Product Discontinuation Notice: EVP-AKB11A Series Light Touch Switch

PDN.PG26.12.7.2018 12.7.2018

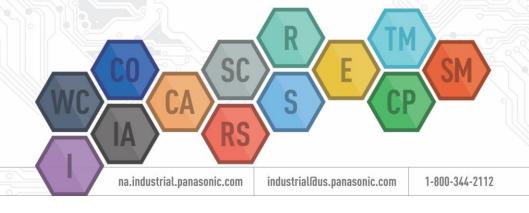
Discontinuation Details: Panasonic will end the production of the "3.8mm x 1.9mm Side Operational SMD Light

Touch Switch" due to low sales demand.

Suggested Replacement: EVP-AKE31A

Conclusion:
According the above comparison result, the two types 3819 EVPAKB11A and EVPAKE31A can be used pin to pin.
When customer use EVPAKE31A to replace the EVPAKB11A, it will not influence the set design and product assemble
The two types have different internal structure, and the EVPAKE31A have higher endurance character.
